THE CITY OF KEY WEST
1300 White Street, Key West Florida 33040

Multimodal Transportation Comments:

5 Easement - 401 South Street (RE# 00036210-000000)

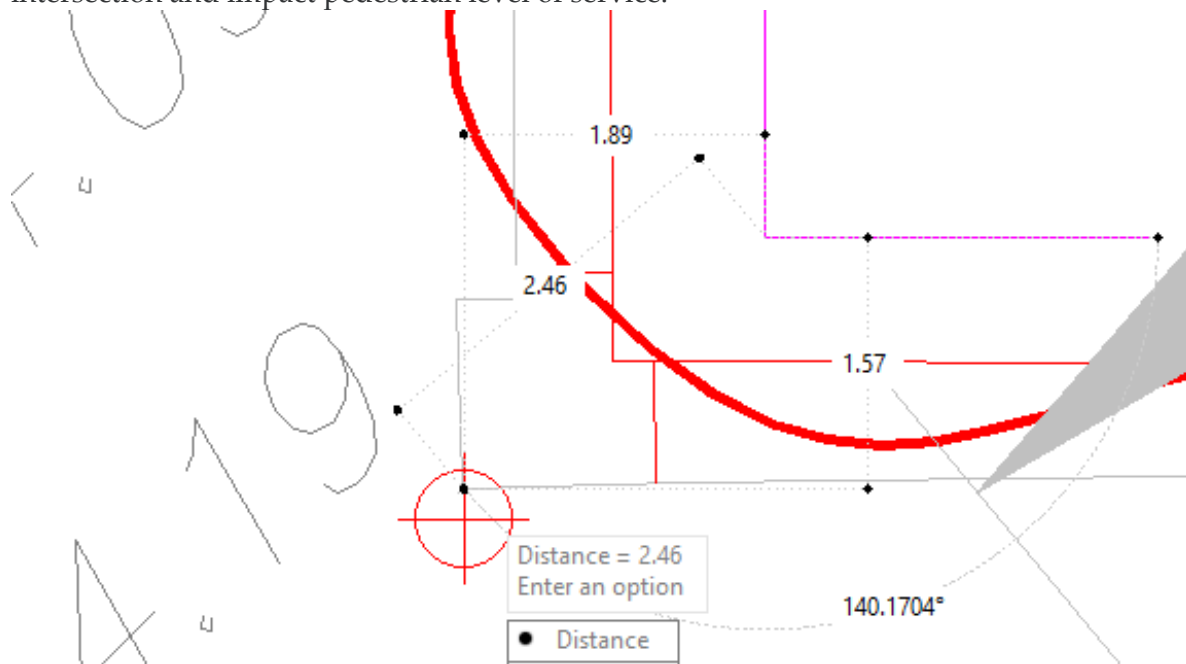
- The City of Key West was provided with survey as part of the Southernmost Point Plaza project currently in the design phase, and a snapshot of the inside corner of South St and Whitehead St is shown below. The encroachment, exaggerated at the corner, would restrict the public travel width by approximately 2.46'. An easement would restrict available public space within a heavily pedestrianized intersection and impact pedestrian level of service.
